TRUCK, UTILITY, LIGHTWEIGHT, MC2 - LAND ROVER 110 4X4

TRUCK, CARGO, LIGHT, MC2 - LAND ROVER 110 6X6

FITTING OF LINK CABLE TO THE HEADLAMP ELECTRICAL CIRCUIT

MODIFICATION INSTRUCTION

FIG 1 - LINK FITMENT

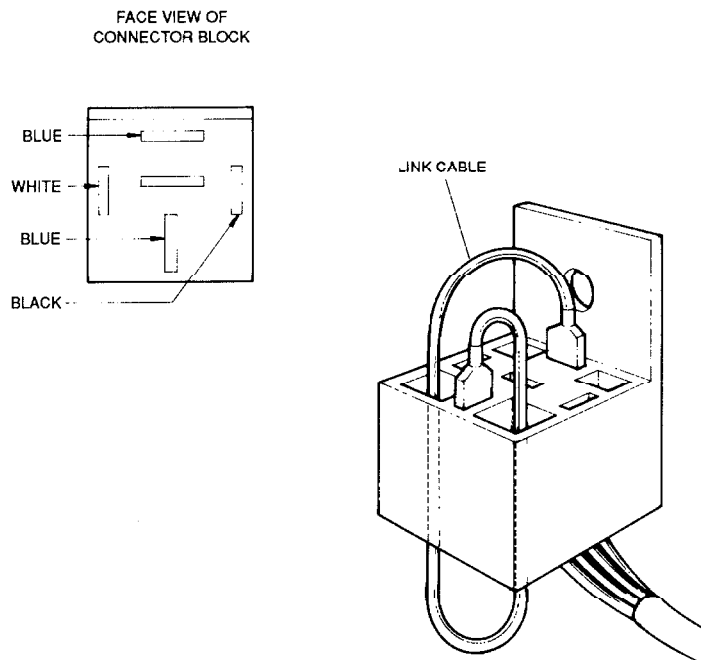
1. This instruction details the removal of the headlight over-ride relay and the fitment of a link cable to the headlight over-ride relay connector block to allow the operation of the headlights with the ignition in the 'off' position. The purpose of the modification is to correct a build error by Land Rover Australia and this instruction details the retrofit of those vehicles not rectified in production.

- c. Turn the ignition and headlight switches to the 'off' position and disconnect the battery terminals.
- d. Fit the link cable (item 1 from Table 1) to the two blue wires as shown in Fig 1, ensuring that the cable is threaded through the block to prevent accidental dislodgement.

1. Ensure that the link wire is installed correctly otherwise wire burnout will occur.
